South Waterfront Code & Design Guideline Update Project

Portland City Council Hearing
Second Reading
January 27, 2010

Sample Amendments

2-1 ADDRESS STREETS AND ACCESSWAYS

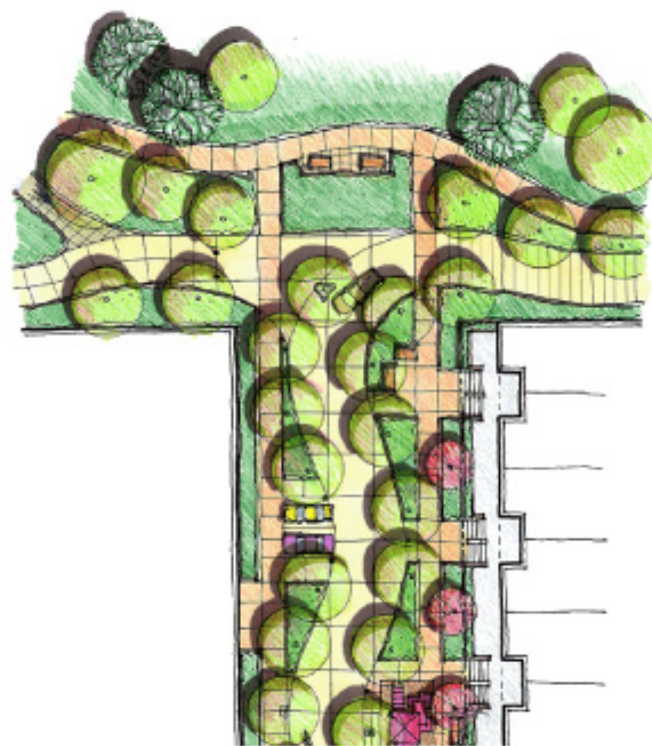
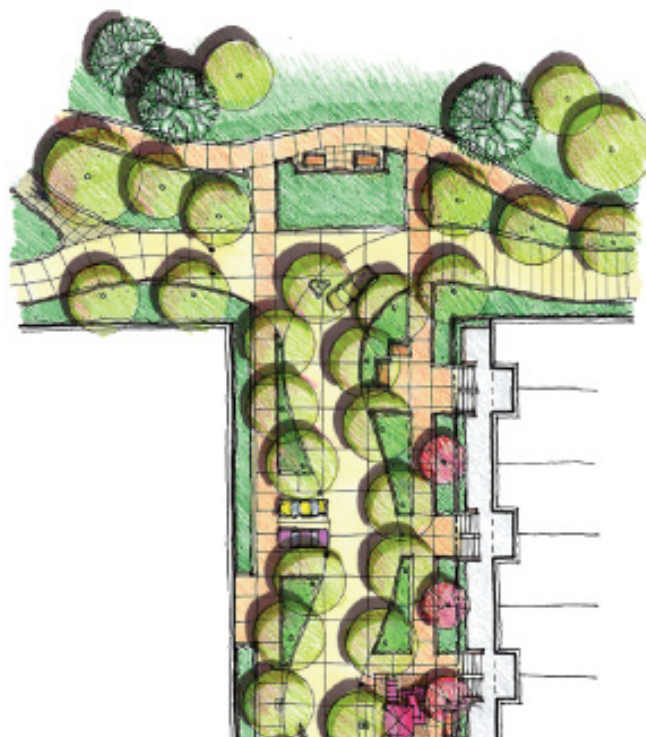
2. Creating east-west "Universal Streets" or fingers of green, extending into the greenway, and providing north-south "Universal Accessways" along the western boundary of development to allow low-volume, limited access and encourage mixed-uses.

This illustration of a Universal Street shows limited access to the greenway which could provide visitor parking, play areas, and semi-private courtyard or planting areas.

2. Creating east-west "Universal Streets" or fingers of green, extending into the greenway, and providing north-south "Universal Accessways" along the western boundary of development to allow low-volume, limited access and encourage mixed-uses.

This illustration of a Universal Street shows limited access to the greenway which could provide visitor parking, play areas, and semi-private courtyard or planting areas.

2-1 ADDRESS STREETS AND ACCESSWAYS

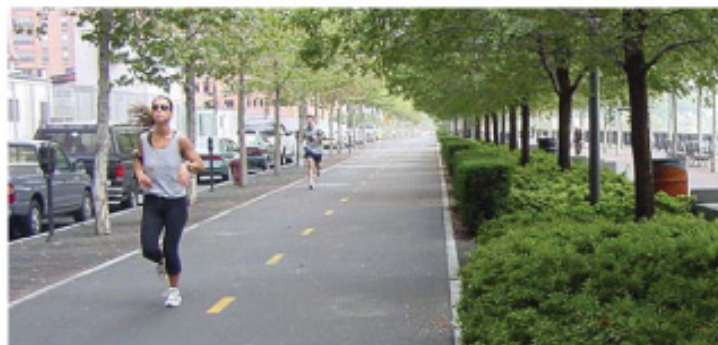
1. Incorporating on-street parking and wide sidewalks where public streets abut the greenway.

These two images show on-street parking and wide sidewalks adjacent to a street along the waterfront trail. The parking acts as a buffer between the street and trail and also encourages public use and connections through the generous sidewalk.

1. Incorporating on-street parking and wide sidewalks where public streets abut the greenway.

These two images show on-street parking and wide sidewalks adjacent to a street along the waterfront trail. The parking acts as a buffer between the street and trail and also encourages public use and connections through the generous sidewalk.
